City of Sandy

Planning Commission Meeting

Meeting Date: Monday,
September 27, 2021

- 8.2. 21-014 SUB/TREE: Deer Meadows Subdivision 93 - 867
[Staff Report for Deer Meadows Subdivision](#)
[Exhibits A-B for Deer Meadows](#)
[Exhibit C for Deer Meadows](#)
[Exhibits D-E for Deer Meadows](#)
[Exhibits F-J for Deer Meadows](#)
[Exhibits K-L for Deer Meadows](#)
[Exhibits M-R for Deer Meadows](#)
[Exhibits S-W for Deer Meadows](#)
[Exhibit X Letter from Michael Robinson](#)
[Exhibit Y Letter from Michael Robinson \(Sep. 24\)](#)
[Exhibit Z Letter from All County Surveyors and Planners \(Sep. 16\)](#)
[Exhibit AA Parks and Trails Advisory Board Minutes](#)
[Exhibit BB Public Comment - Dave Carter \(Sep. 27\)](#)
[Exhibit CC Revised TIS from Ard Engineering \(Sep. 27\)](#)
[Exhibit DD Public Comment - Vincent & Lynn K Mandina \(Sep. 27\)](#)
[Exhibit EE Ard Engineering Response Memo \(Sep. 27\)](#)

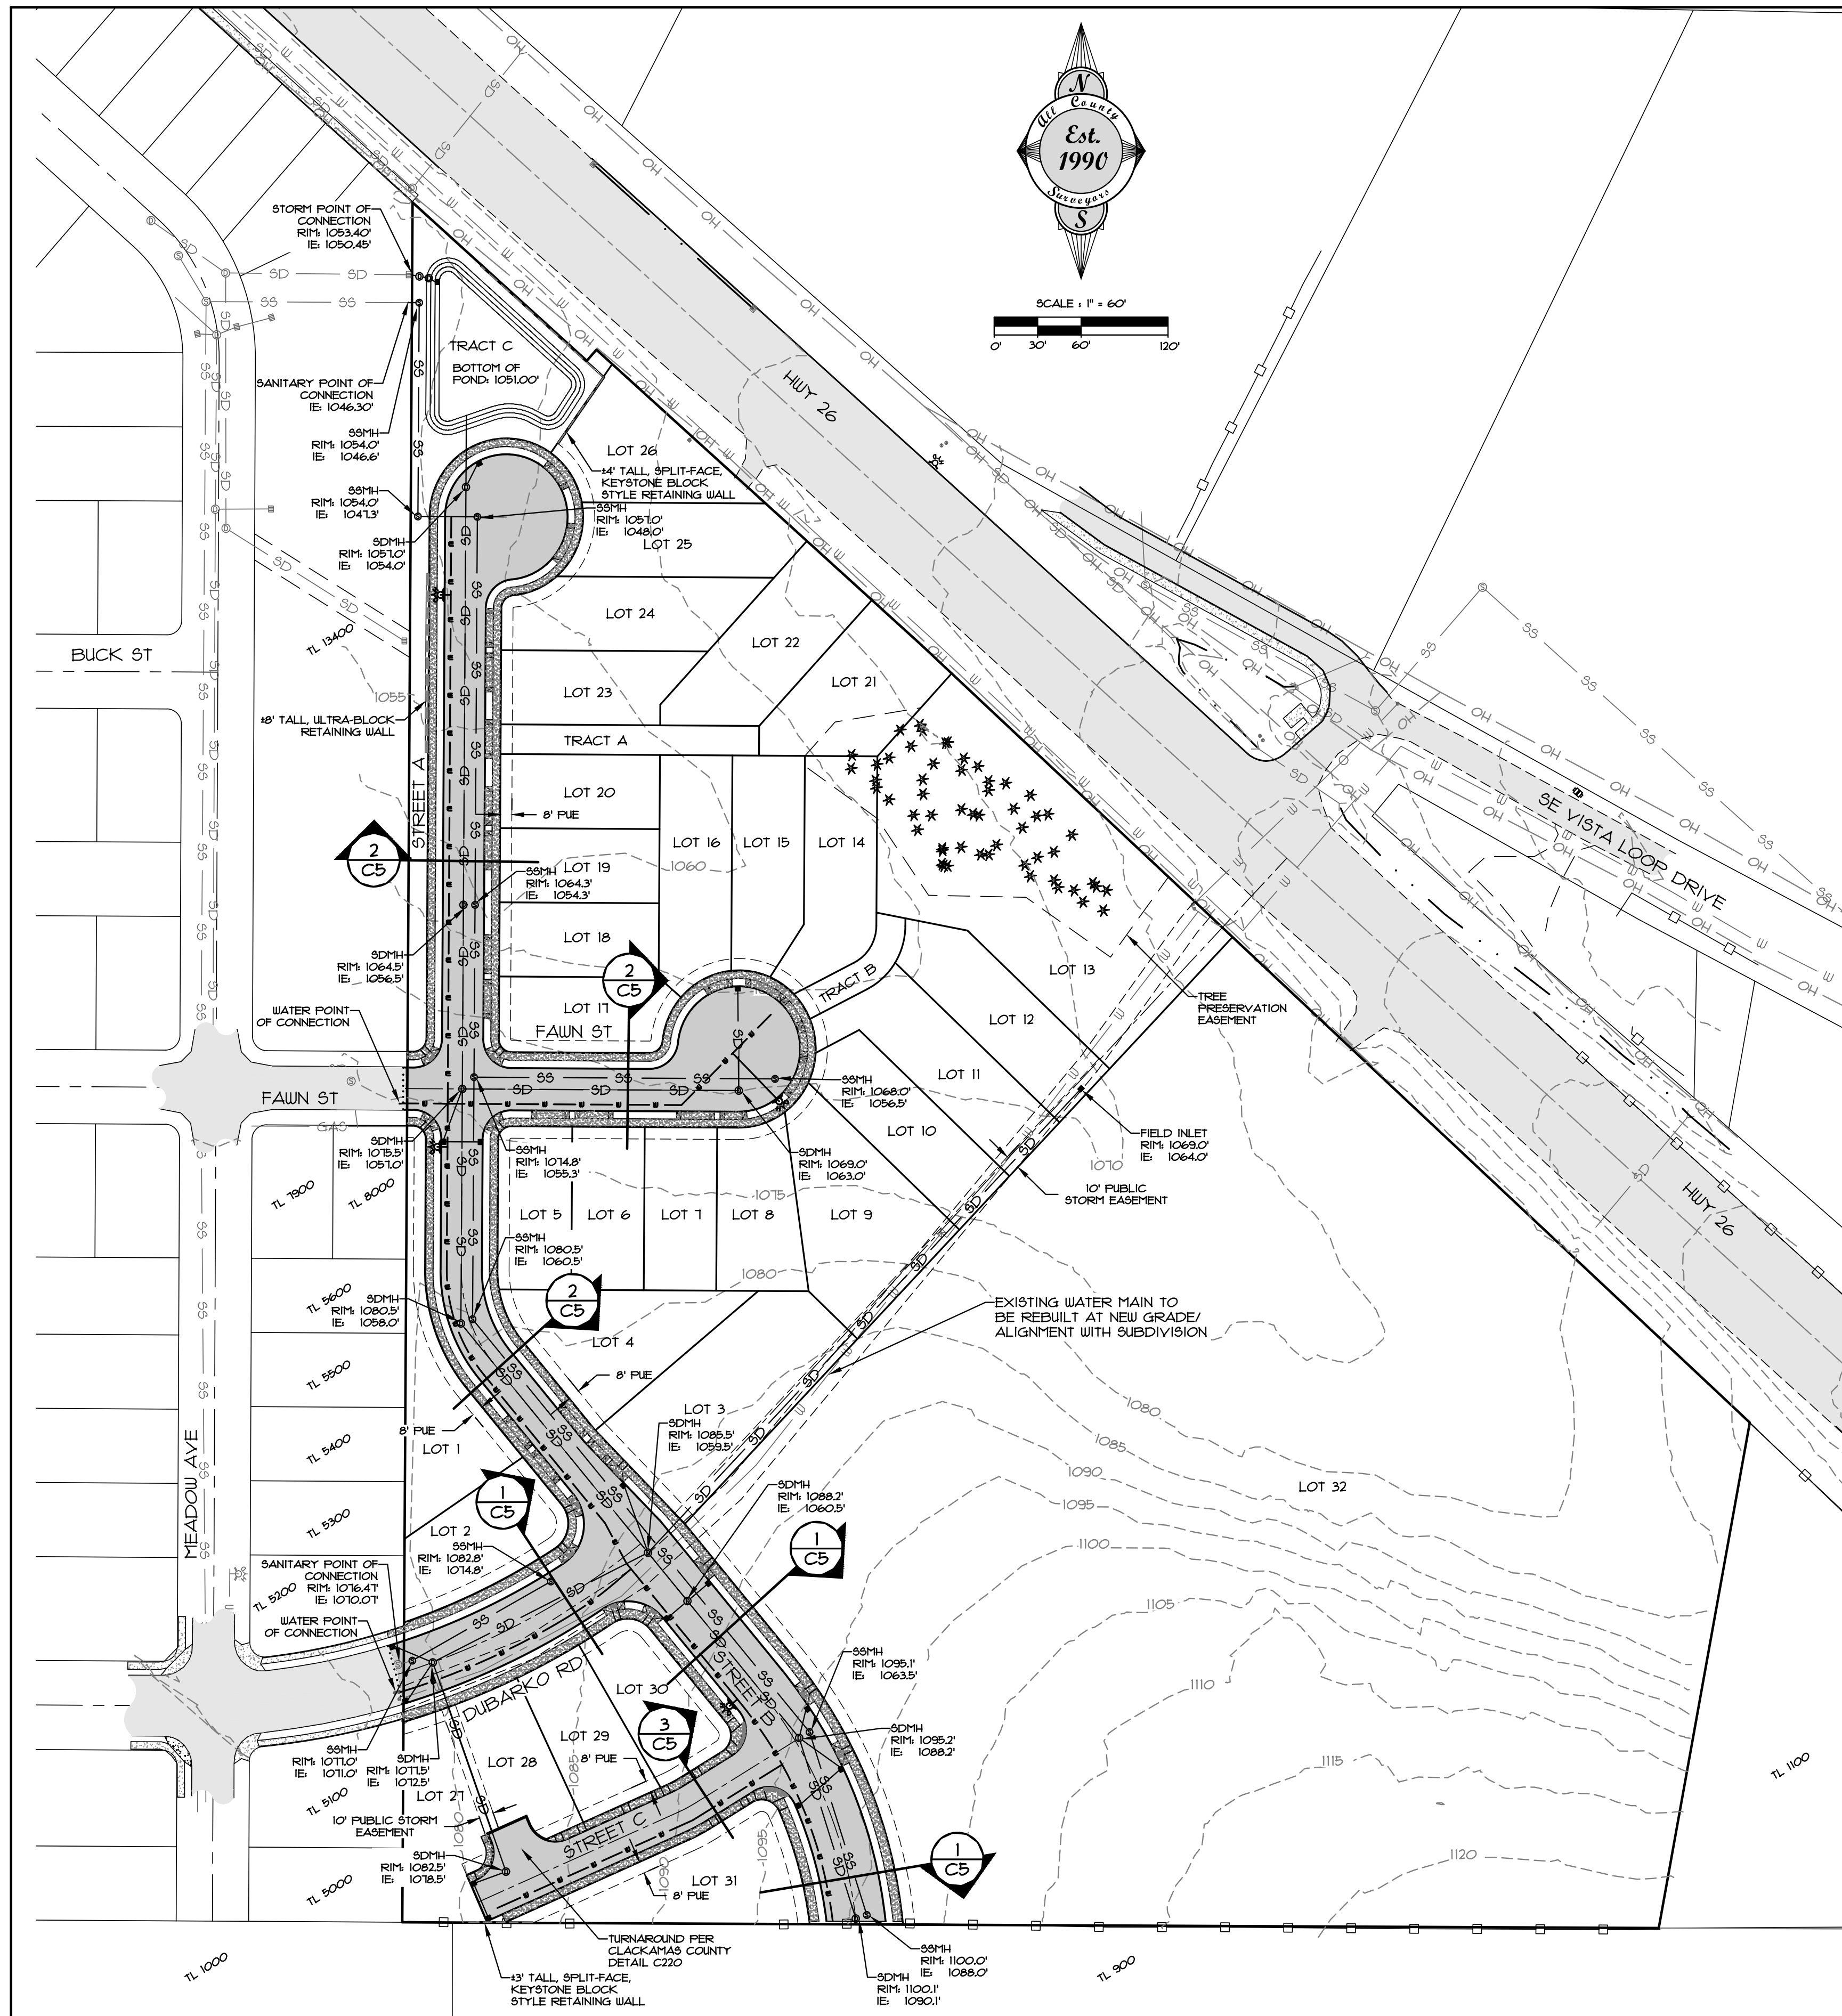
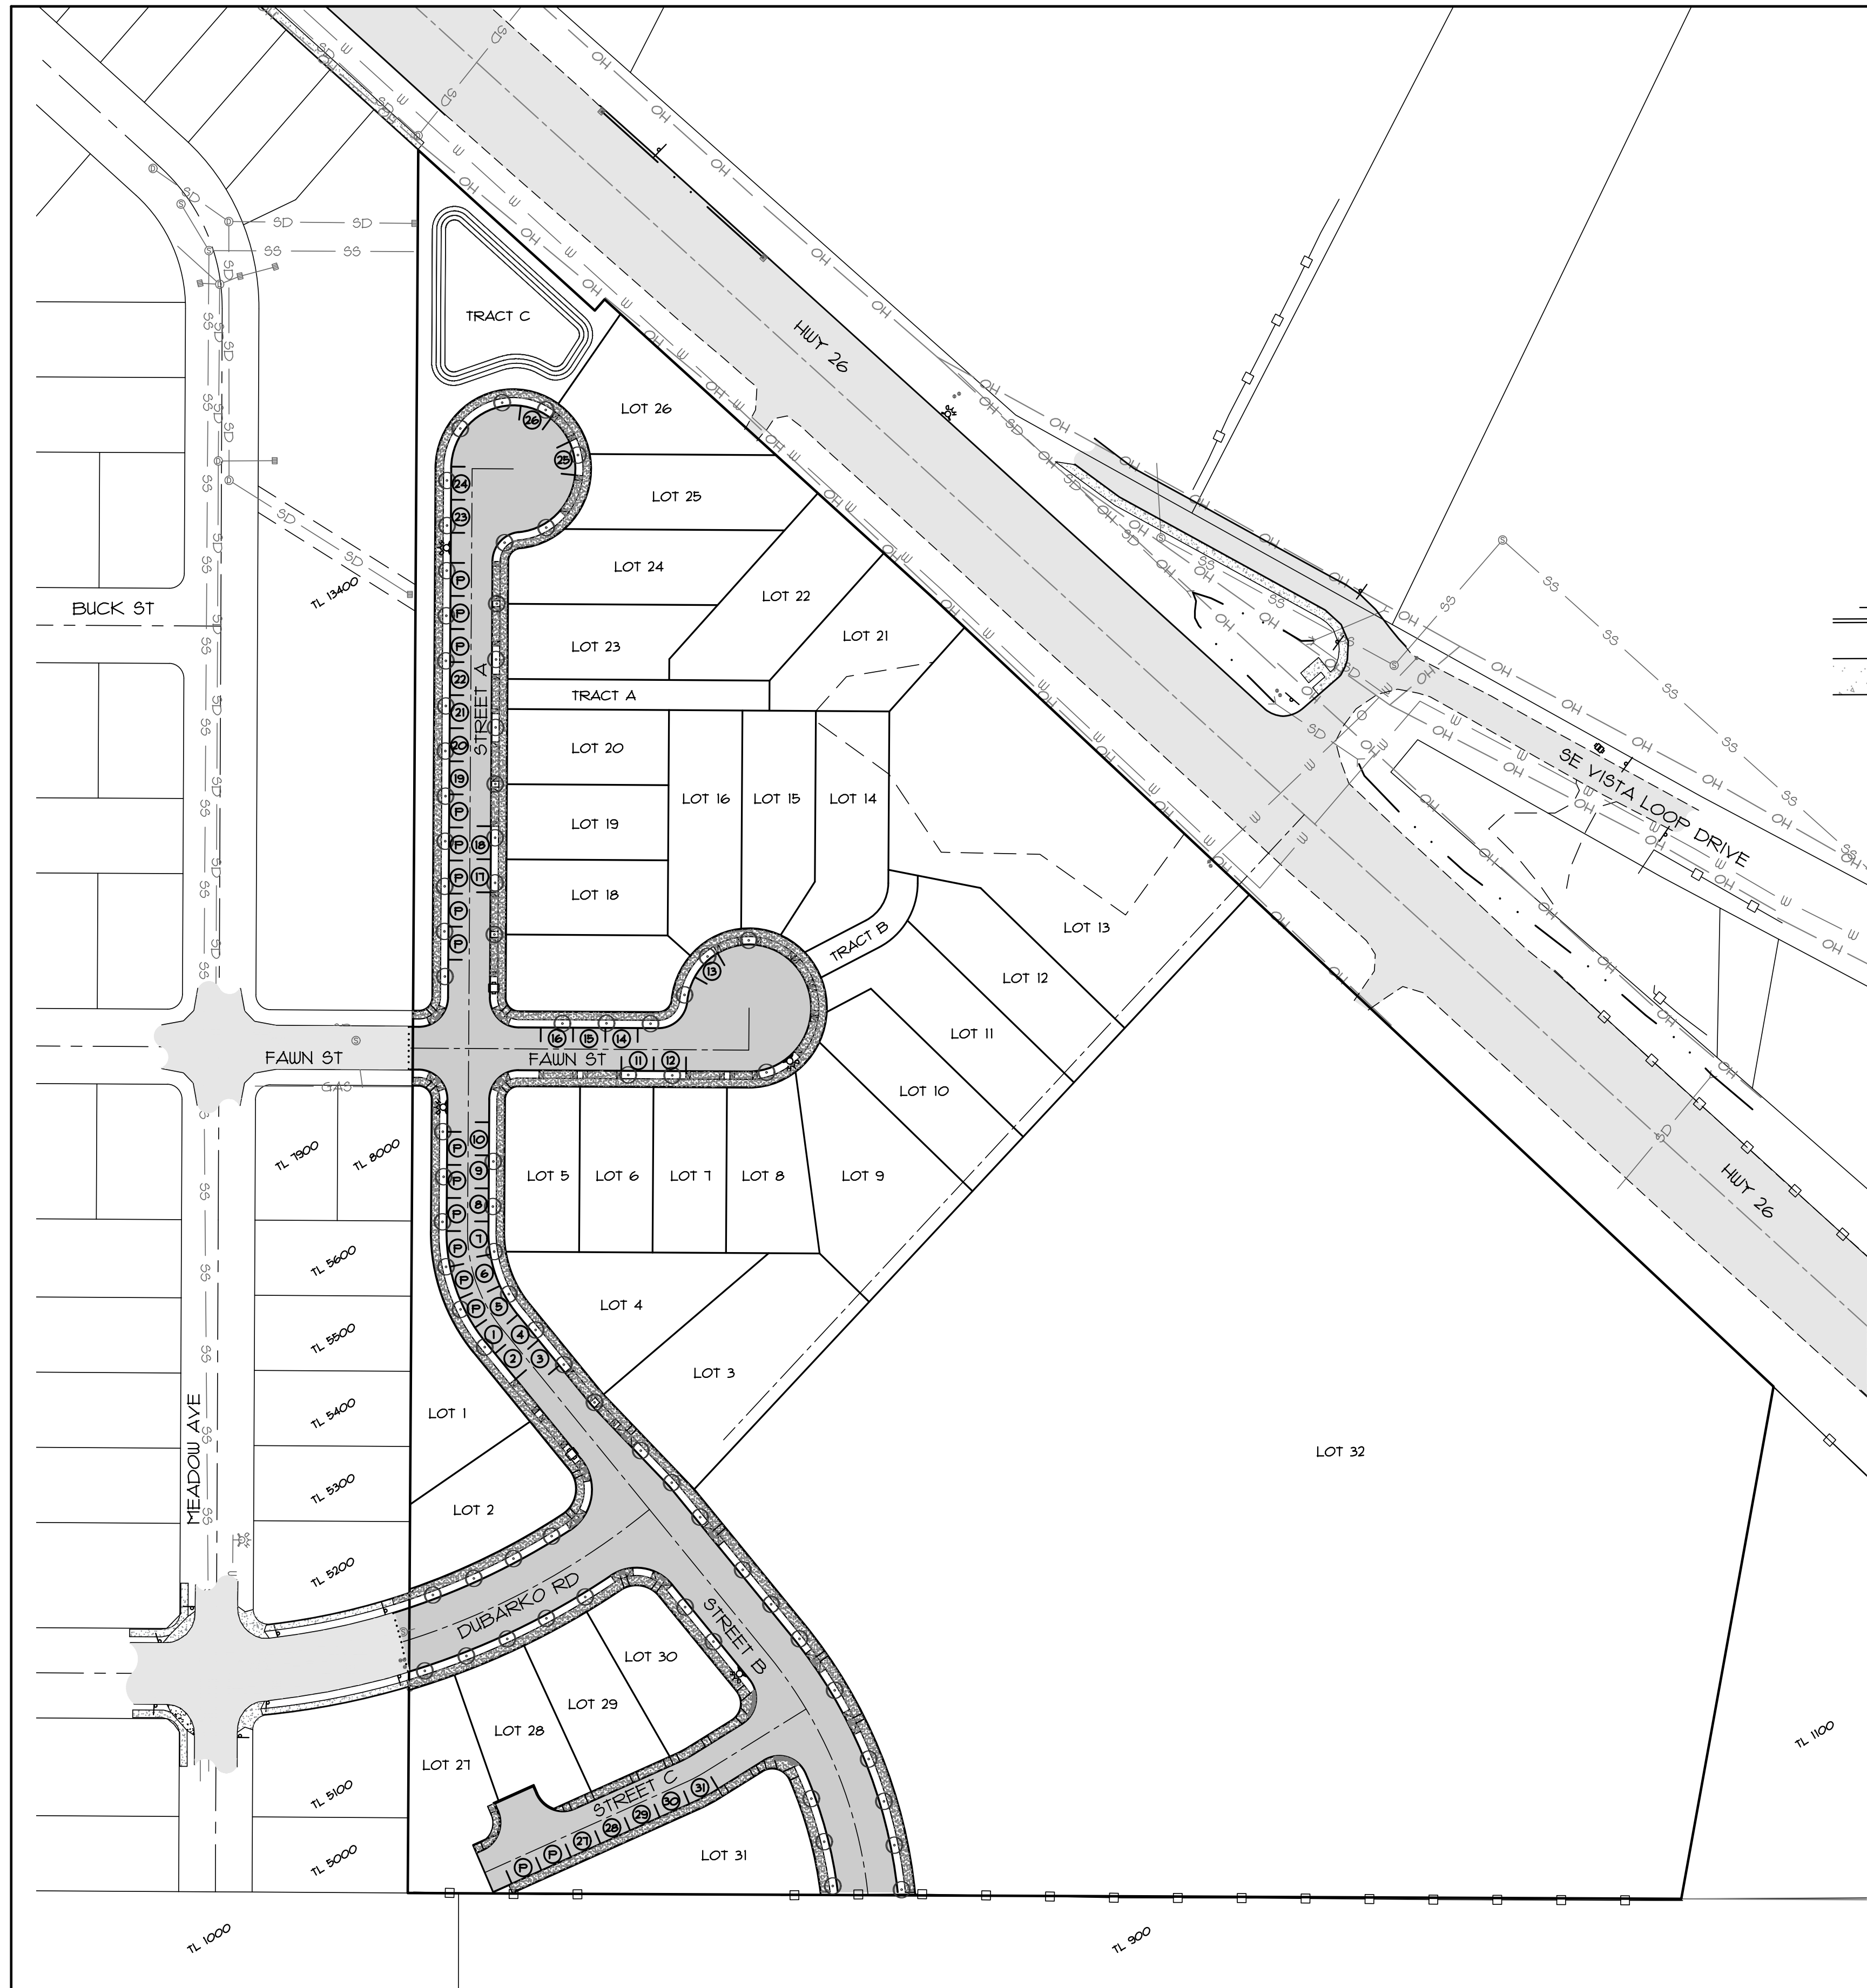
53. In relation to Sections 17.84.30(B), 17.84.30(C), 17.84.30(D), and 17.84.30(E), no pedestrian or bicycle facilities other than sidewalks have been identified or proposed in the subdivision. The plan set (Exhibit C, Sheet C5) does not identify bicycle lanes on Dubarko Road or Street B. **The applicant shall revise the plan set to include bicycle lanes on Dubarko Road and Street B.**

63. Section 17.84.60 outlines the requirements of public facility extensions. The applicant submitted a utility plan (Exhibit C, Sheet C5) which shows the location of proposed public water, sanitary sewer, and stormwater drainage facilities. **Broadband fiber service shall be detailed with construction plans.**

Sheet C5 of the applicant's submission contains a statement indicating that "Both of the proposed cul-de-sacs have less than 50% of their circumference covered by driveway drops". No dimensional information is shown on the site plan to support this statement. The location, number and width of all driveway approaches in cul-de-sacs shall not exceed the dimensional standards in section 17.98.100 SMC.

RESPONSE: **Exhibit 2**, attached hereto, provides driveway width information for the Fawn Street and Street A cul-de-sacs. This exhibit demonstrates that the sum of the driveway widths for each cul-de-sac is less than 50%. SDC 17.98.100.F is satisfied.
